**CITY OF LEBANON
PLANNING AND ZONING DEPARTMENT**

**CITY OF LEBANON PLAN COMMISSION
STAFF REPORT
MARCH 20, 2023 PUBLIC HEARING**

A. Case Number:	Docket # 23-13
B. Applicant:	Cash Waggener & Associates for the Lebanon Community School Corporation
C. Location:	The subject property is located at 1500 Garfield Street, Lebanon, Indiana, 46052 (Harney Elementary).

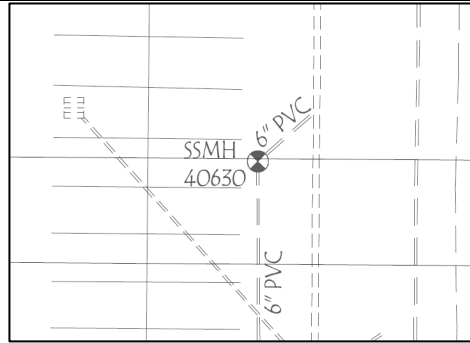
- Ensure the most recent set of Lebanon City Standards are included. The most recent set is dated 01/01/2022 and can be found at the link below.
<https://lebanon-utilities.com/wp-content/uploads/2021/12/Lebanon-City-Standards-Final-Version-010122.pdf>
- The new improvements appear to be in conflict with the existing underground water line. Provide plans for relocation of the water line around the improvements and indicate any new connections that may be needed.

- The water meter for the facility shall be moved from inside the building to a vault in accordance with Sheet 12 of the City Standards.
- Sanitary laterals shall be 6-inch PVC SDR 26.
- The plans appear to show a cross connection at SSMH 40630. Please confirm that the storm sewer is not connected to the sanitary sewer at this structure.

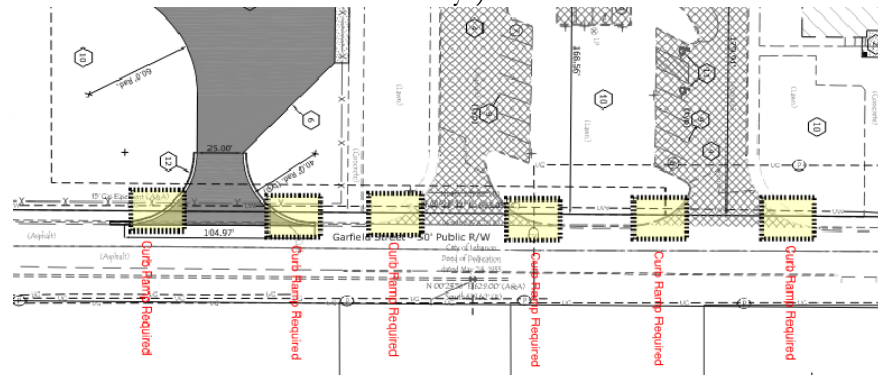
- Existing streets adjacent to widening are to be milled to a depth of 2" and resurfaced.
- Ensure all proposed walks and crossings are ADA compliant:
 - Proposed crossing of the new parent staging lane at Harney and Camp will require stop sign or proper signage for a midblock crossing.

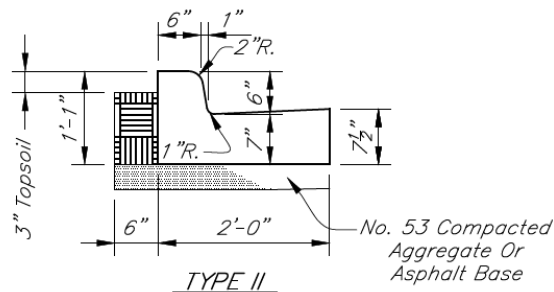
- Sidewalk curb ramps and crossings along Garfield to be replaced with ADA compliant ramps (no truncated domes are required for commercial driveways):

2' COMBINED CONCRETE CURB & GUTTER

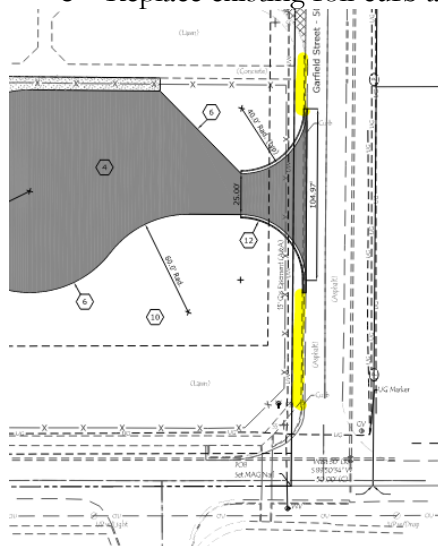
- All curbing within the right-of-way (widening) shall be 2' COMBINED CONCRETE CURB & GUTTER, per City of Lebanon Standards:

- Regrading may be needed to ensure proper gutter drainage.
